1. Revised Conservation Agenda-2-26-2026

Town of Franklin

Conservation Commission

BETA Group, Inc. (BETA) has reviewed documents and plans for the proposed construction of a single-family dwelling (the Project) off of **Lewis Street** in Franklin, Massachusetts (the "Site").

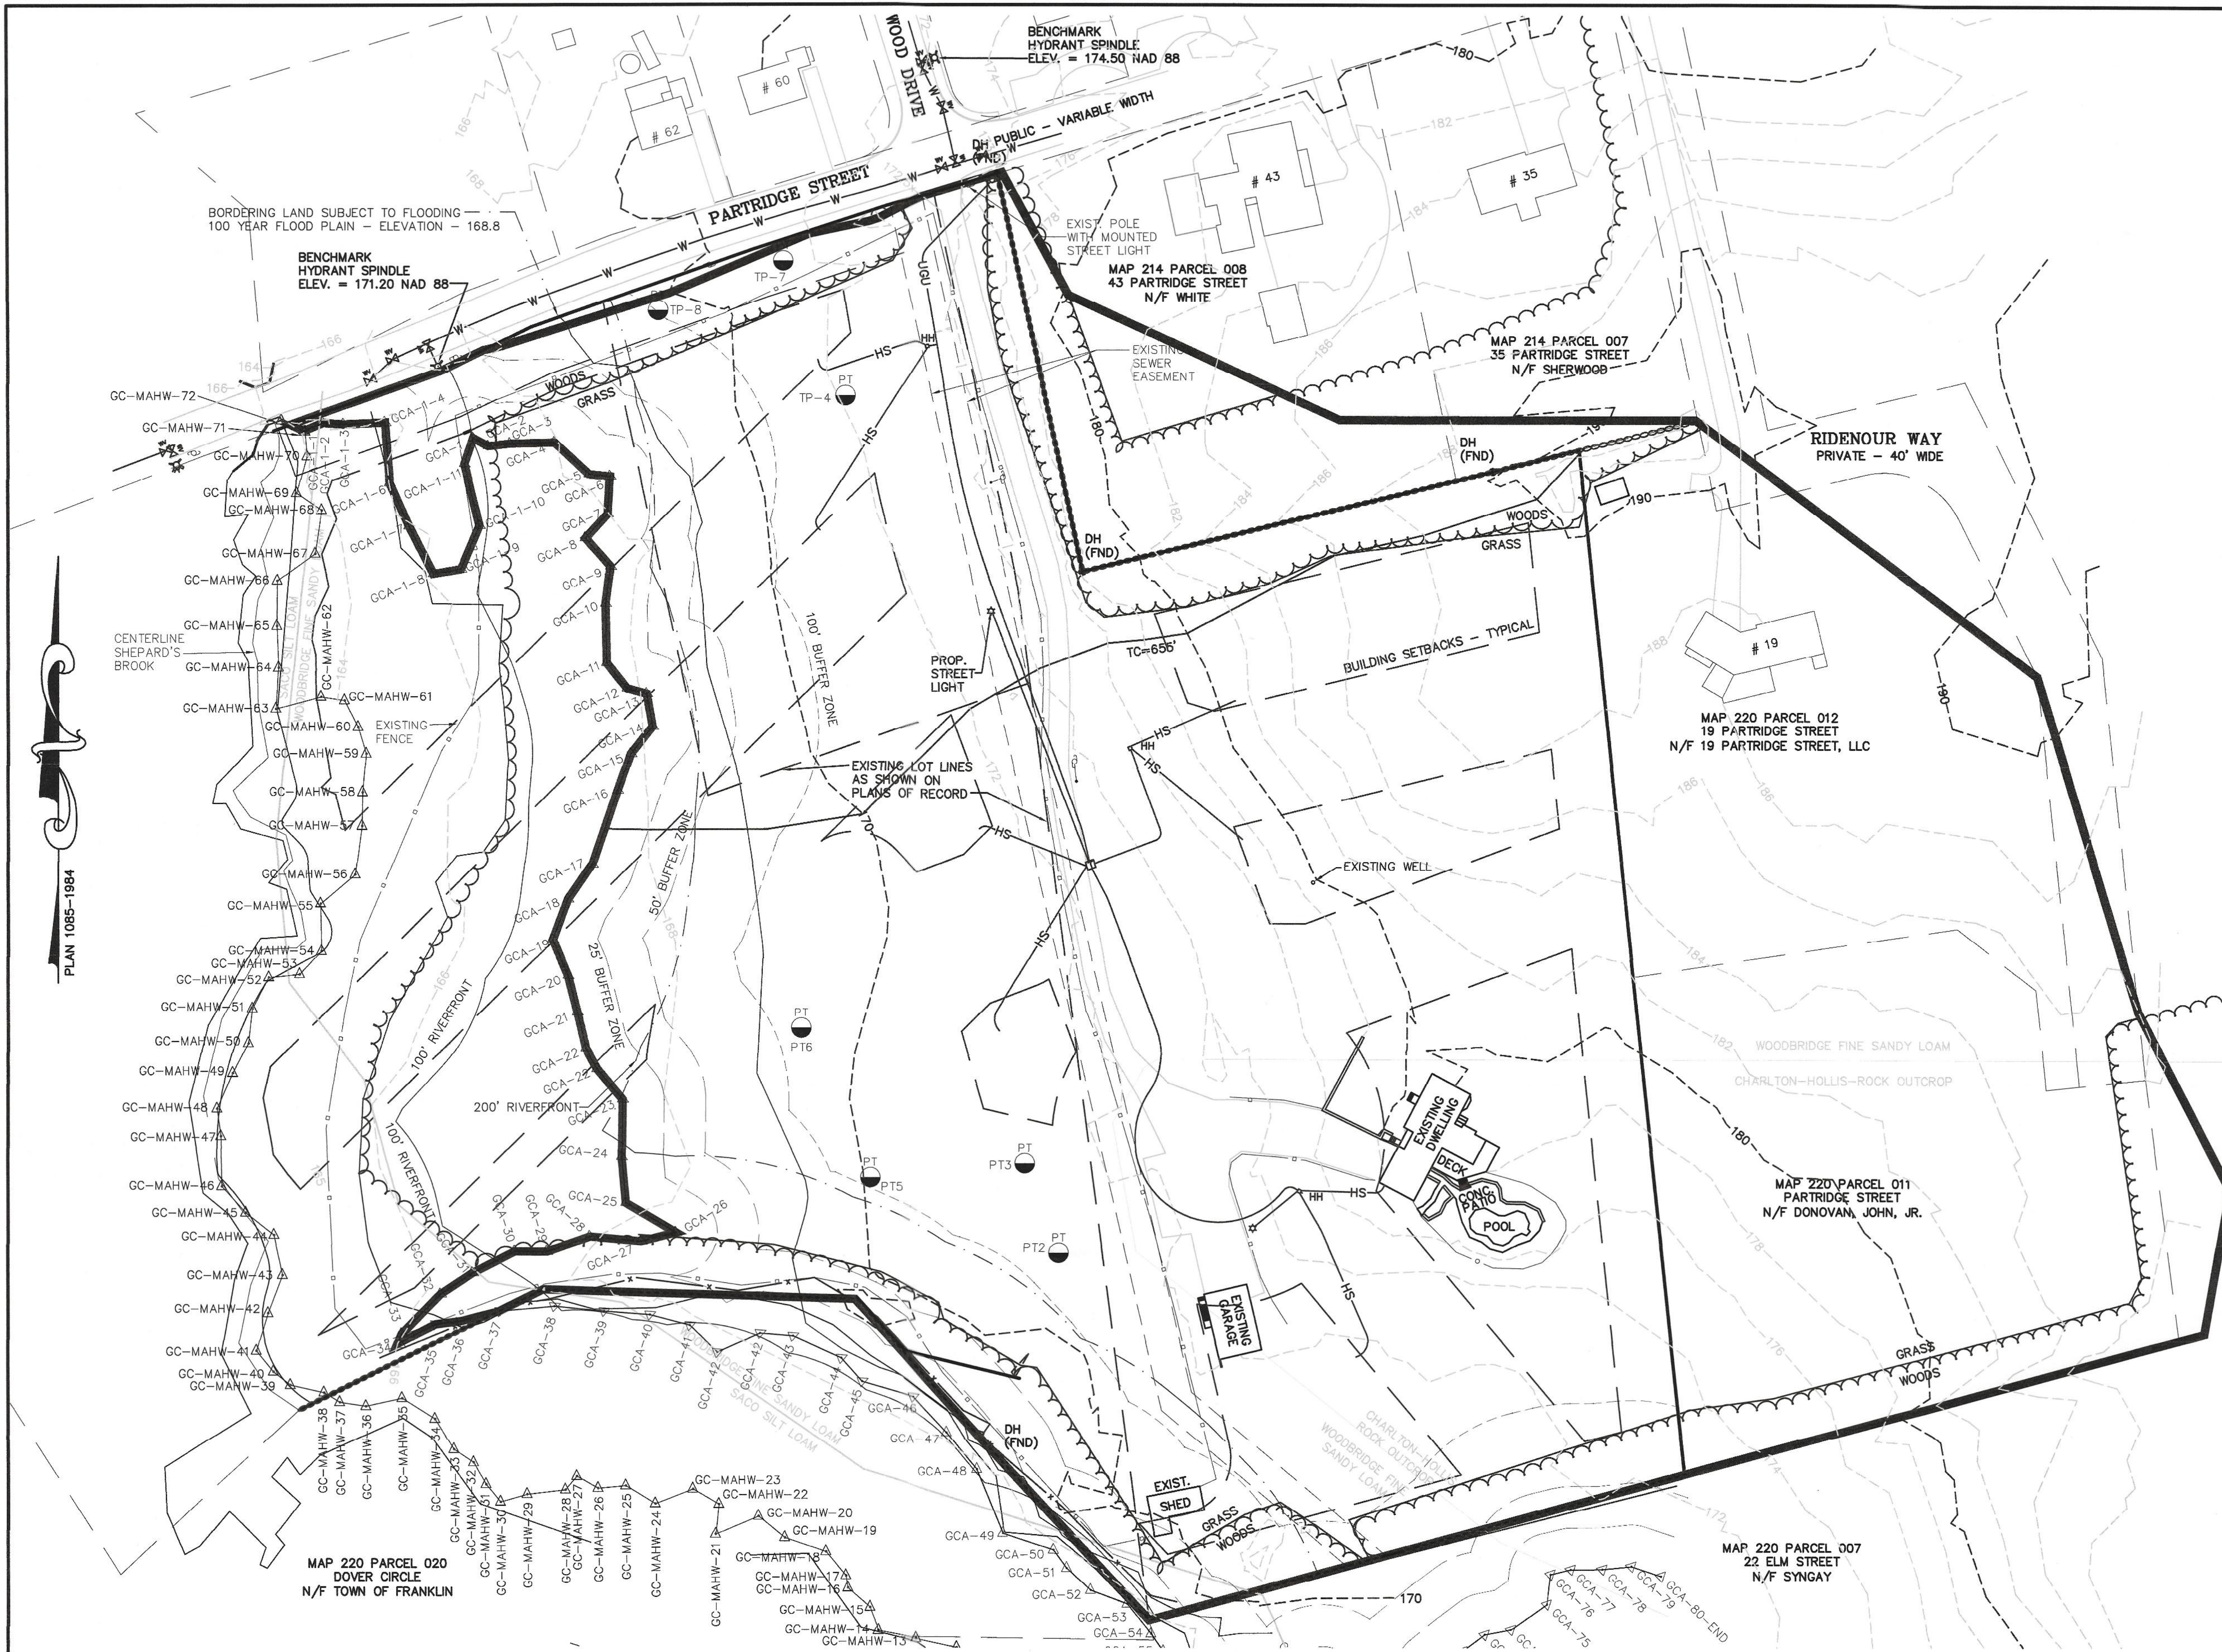
MassDEP recommends that the applicant demonstrate that adequate separation exists to allow the installation of the proposed sewer line and existing stormwater culvert which conveys flows developed parts of Lewis St to downgradient wetlands and provide details on how this stormwater conveyance will be maintained during project construction.

- a. Existing and proposed vegetation should be included on the plans as referenced in Bylaw Regulations Section 7.18.1.5 and 7.18.1.6, including individual trees/shrubs with a diameter greater than 1" proposed for removal. It is BETA's understanding that the Commission generally increases the size threshold for tree location based on the Project and therefore defers to the Commission on this matter. However, the existing tree line, areas of proposed lawn, and any other proposed vegetation should be depicted on the plans.
- b. A Construction Sequence with all proposed activities within Jurisdictional Areas should be provided on the plans per Bylaw Regulations Section 7.18.1.14.
- c. A PLS stamp should be provided on the plans to verify the existing conditions survey.

- A3. Impacts to both the 25-50-foot and 50-100-foot Buffer Zone should be noted on the plans.

- W1. Provide specifications of the seed mixture(s) proposed for stabilization of disturbed areas within Buffer Zone, including any areas that are proposed to be lawn. All areas of proposed lawn should be demarcated on the Project plans.

Per the Erosion & Sediment Controls Notes on the plans, Note 6 provides a suggestion for proposed seed that consists of non-native grasses for stabilization. BETA recommends that native species with wildlife habitat value be proposed within Buffer Zone where lawn is not required as mitigation for Buffer Zone clearing.

- W2. The Applicant should provide a cross section to demonstrate that the proposed sewer can be constructed over or under the existing drain without conflict.

- W3. Material storage and laydown areas should be depicted on the Project plans and located outside of jurisdictional areas to the extent feasible.
- W4. Groundwater may be encountered when excavating for the new foundation and utilities. The Commission could include a Special Condition in the order of Conditions requiring the submission and approval of a dewatering plan prior to discharge in the event that groundwater is encountered.

- W5. The Applicant should consider providing a planting plan to mitigate for additional development within Buffer Zone. Specifically, areas within Buffer Zone closest to BVW should be prioritized for the planting of native vegetation and the application of native seed mix.

- W6. The Applicant should quantify impacts to the 0-25-foot No Disturb Zone, as the proposed tree line depicts vegetation clearing within this Buffer Zone up to the BVW boundary at one location. Additionally, erosion and sedimentation controls should be depicted at the limits of work in this area. If the Commission permits this vegetation clearing, BETA suggests that the Commission include a Special Condition requiring the Applicant to provide signage at the proposed limits of work to prevent future encroachments further into jurisdictional areas.
